COUNCIL ASSESSMENT REPORT

Panel Reference	2018HCC010
DA Number	DA/419/2018
LGA	Lake Macquarie City Council
Proposed Development	Mixed use development with commercial premises and residential flat building
Street Address	114-120 Cary Street, 1, 2, 3, 5 Bath Street and 3 Arnott Avenue, Toronto
Applicant/Owner	Toronto Investments No.1 PTY LTD C/- Mark Lawler Architects
Date of DA lodgement	15 March 2018
Number of Submissions	20 submissions (19 against and 1 in support)
Recommendation	Approval subject to deferred commencement
Regional Development Criteria (Schedule 7 of the SEPP (State and Regional Development) 2011)	General development that has a Capital Investment Value over the \$30 million threshold for Regional Development
List of all relevant s4.15(1)(a) matters	<ul style="list-style-type: none"> • State Environmental Planning Policy (State and Regional Development) 2011 • State Environmental Planning Policy (Infrastructure) 2007 • State Environmental Planning Policy (Building Sustainability Index) 2004 • State Environmental Planning Policy No.14 (Coastal Wetlands) • State Environmental Planning Policy No. 55 (Remediation of Land) • State Environmental Planning Policy No.65 (Des

Figure 8 – Section A (West – East section)

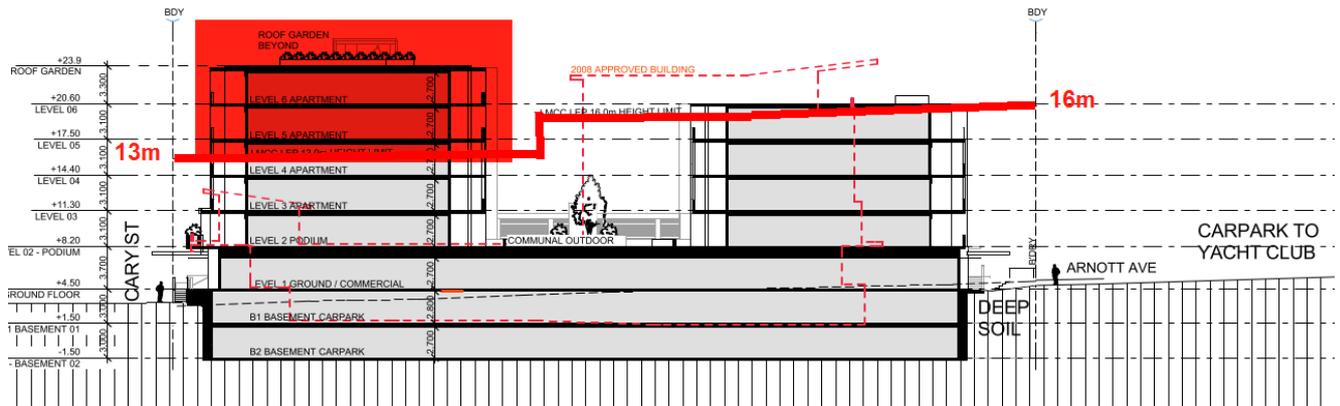
Having regard to the Cary Street building block, the areas in breach are shown in red hatching of Section A (refer to Figure 8). As can be seen in Figure 8, the breach equates to 2.5 storeys to the top of Level 6 and 3.5 storeys to the top of the rooftop terrace.

The breach to the Arnott Avenue, as depicted by the red line in Figure 8 below, is considered minor and of little consequence.

Following a detailed analysis of building height, Council considers a five storey development with roof top terrace on Cary Street a more contextually appropriate response to the site. Accordingly, it is the recommendation of this report by way of deferred commencement that Level 6 be deleted from the Cary Street block. This would result in the following height:

Figure 10 – Site context location and sections

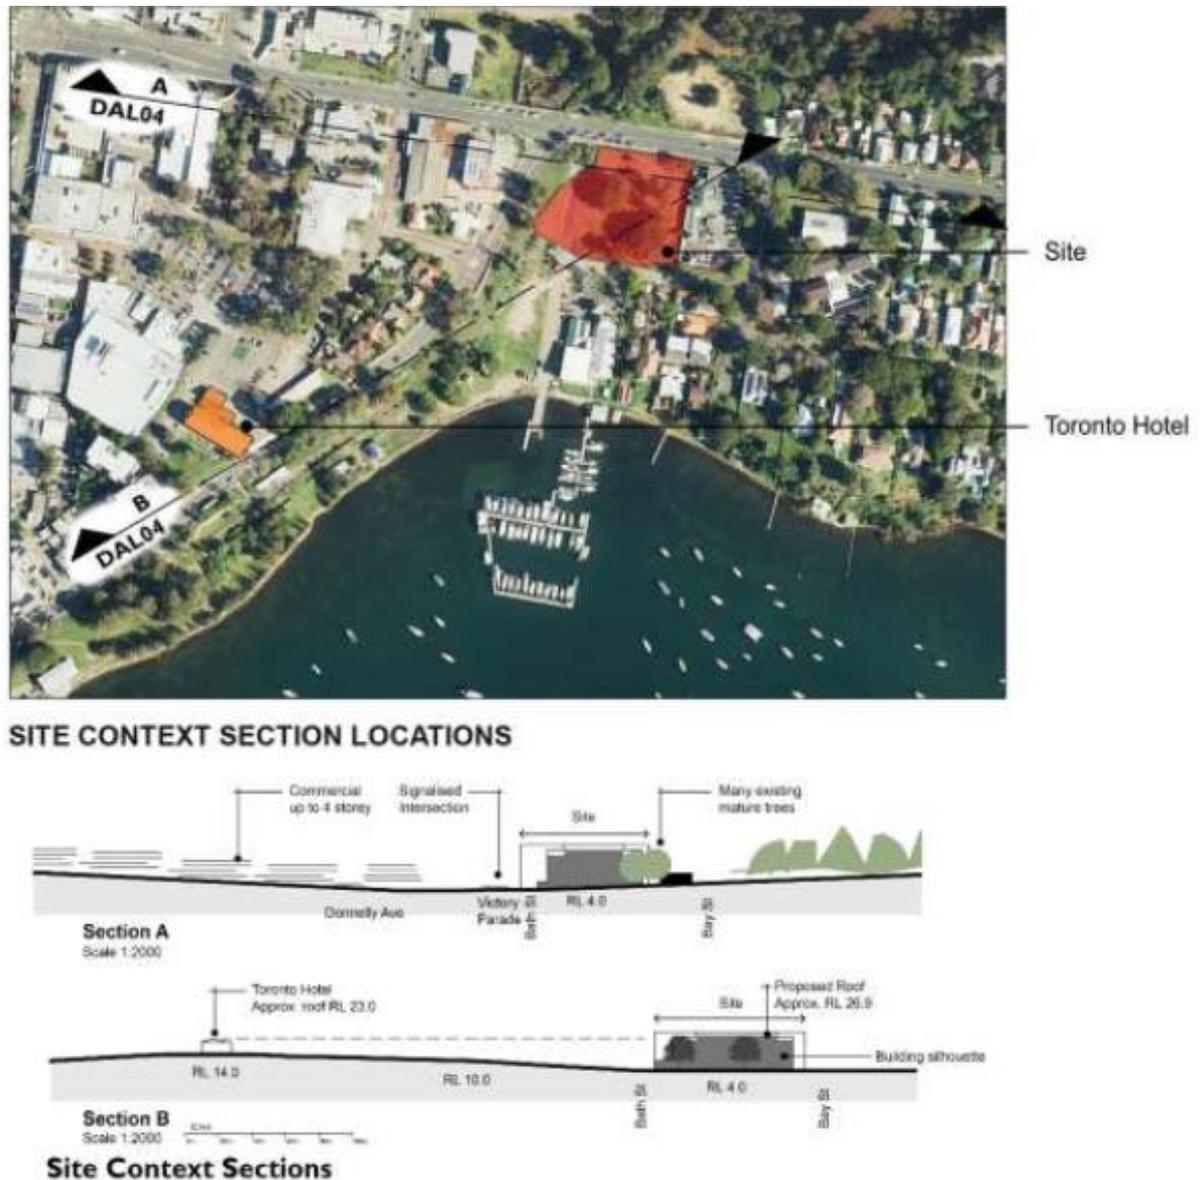
Comment: Having regard to the above Toronto Area Plan controls, the submitted VIA, prepared by Mansfield and dated 15 August 2018, indicates the proposal exceeds the height of the Toronto Hotel (refer to Figure 10 below), a benchmark control reiterated throughout the Toronto Area Plan.

It is considered the two buildings will be viewed comparatively within the broader Toronto townscape context, particularly lake based views. This breach ignores the stated outcomes of the Toronto Area Plan and necessitates a landscape response of tree planting along the south-eastern corner to visually mitigate comparative views and dominance of the proposal within the township context. The viability of the landscape

response given the location of overhead services and minimum deep soil zones is questionable.

The view from the Lake is only softened and minimised by the proposed landscaping, as shown in the elevation plans (refer to Figure 2-4). Council's Heritage Planner is concerned that should this landscaping fail, then the visual prominence of the Toronto Hotel could be compromised.

Figure 20 – Block F control plan

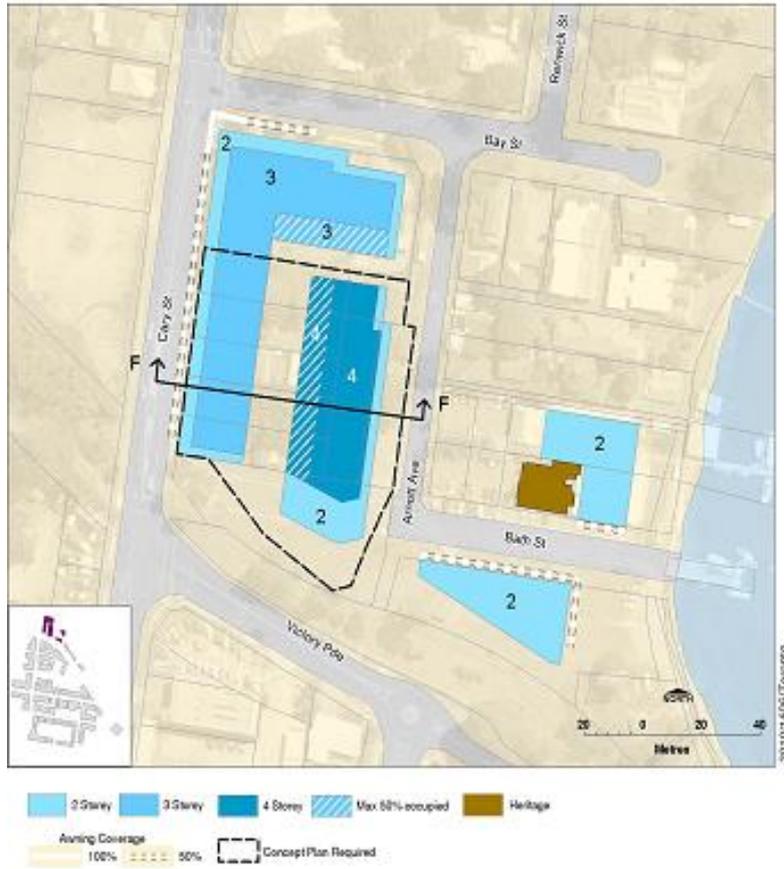
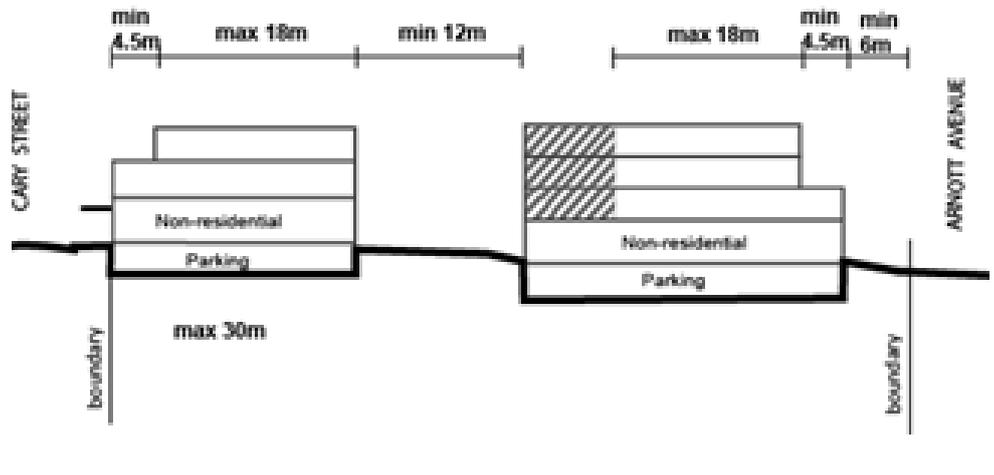
The block controls (refer to Figure 20-21) require the following:

- Cary Street: two storeys to the street with a 4.5m setback for the third storey;
- Victory Parade: two storeys;
- Arnott Avenue: two storeys to the street with a 6m setback with an additional 4.5m setback for the third and fourth storey.

The development is contrary to the block control as follows:
